AMENDMENT TO THE DRAWINGS

REMARKS

Jouni MATULA Appl. No. 10/574,694

Clements discloses a gas and oil burner having a firing chamber 8 and chamber 14 which feeds gaseous fuel or atomized liquid fuel to the firing chamber, as shown below in the annotated Figure 1 from Clements:

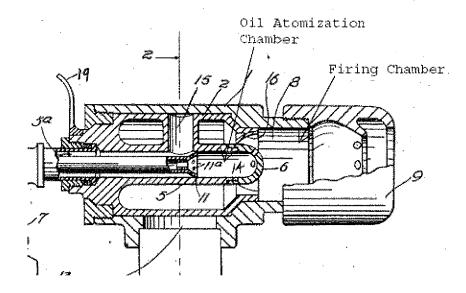
The firing chamber 8 in Clements is not a "process liquid flow duct" as is suggested in the Office Action at page 4. See Clements, col. 1, lns. 50-52, col. 2, lns. 25-29. Liquids do not flow into the firing chamber in Clements. The firing chamber receives gaseous fuel, Clements col. 1, lns. 50-52, or gasified fuel oil, Clements, col. 2, lns. 25-29, see also, col. 2, lns. 17-19. Because the firing chamber in Clements is not a process **liquid** flow duct, there is no anticipation.

Clements discloses a burner to burn gases, including gaseous fuel and gasified fuel oil. The liquid fuel oil entering the Clements burner is gasified in the chamber 14 using high pressure air to atomize the fuel oil. Clements, col. 2, lns 18-30. The gasified fuel oil is a gas as it passes through the nozzle 6 of chamber 14 and enters the firing chamber 8. Liquids are not gases. A liquid is a different phase of matter from a gas.

The air passage in Clements is not a liquid feeding duct. The Office Action at page 5 applies an air passage disclosed in Clements as a "feeding liquid duct." The air passage in Clements includes the air supply conduit 5 that supplies air for the firing chamber 8. Clements, col. 38-42. An air passage is not a "feeding **liquid** duct" as is required by the claims.

There is also no anticipation because the claims, as amended, require a closed end of the mixing liquid feed duct and that the closed end be impervious to the flow of the mixture. A closed end has no openings in the end of the duct, as is shown at 156 in Figure 3 of this application. The oil and gas burner shown in Clements has nozzle orifices 6 in the end of firing chamber 8 and, thus, does not have a closed end.

There is also no anticipation because the claims require mixture discharge opening in the sidewall of the mixing liquid feed duct, and Clements discloses mixture discharge openings at the end of the chamber 6.
